**Project: White Deer Run Reservoir**  
**Project #: PW2017.010**  
**Bid Number: #23002**  
**Addendum #3**  
**Date: April 5, 2023**

### **BID DUE DATE EXTENSION**

### **QUESTIONS RECEIVED**

**TYPICAL SECTION FOR GENERATOR ROOM**  
**SCALE: 1/4" = 1'-0"**

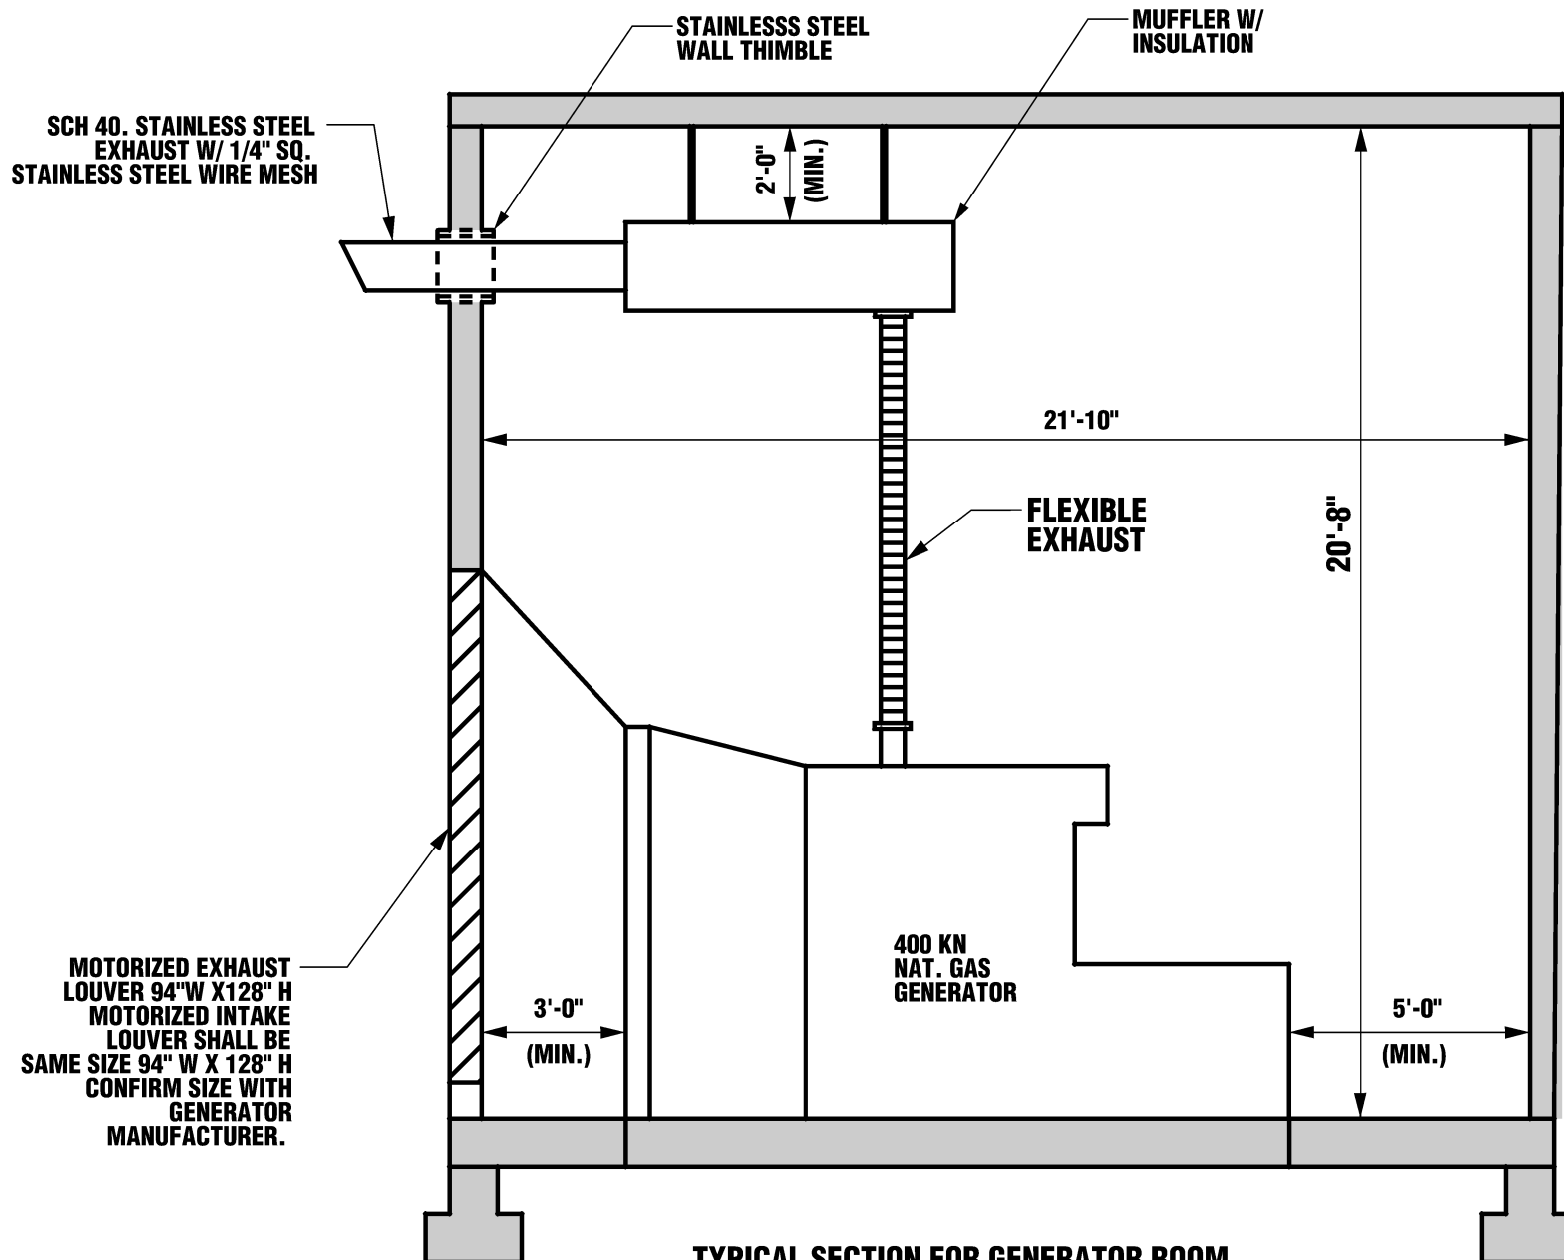
Question 46: Limited detail for the generator is shown in the Plans. On projects with similar scope, the generator required exhaust ductwork for the radiator, a muffler/silencer, an exhaust stack through the roof or wall, motor operated damper on the intake louver that closed when the generator was not running so the room wouldn't get so cold in the winter. Please provide comment, confirm all requirements for the generator.

Answer 46: The generator shall be supplied with motorized intake and exhaust louver/dampers, exhaust ductwork and wall thimble and discharge shroud. See attached typical section drawing for the generator as attached.
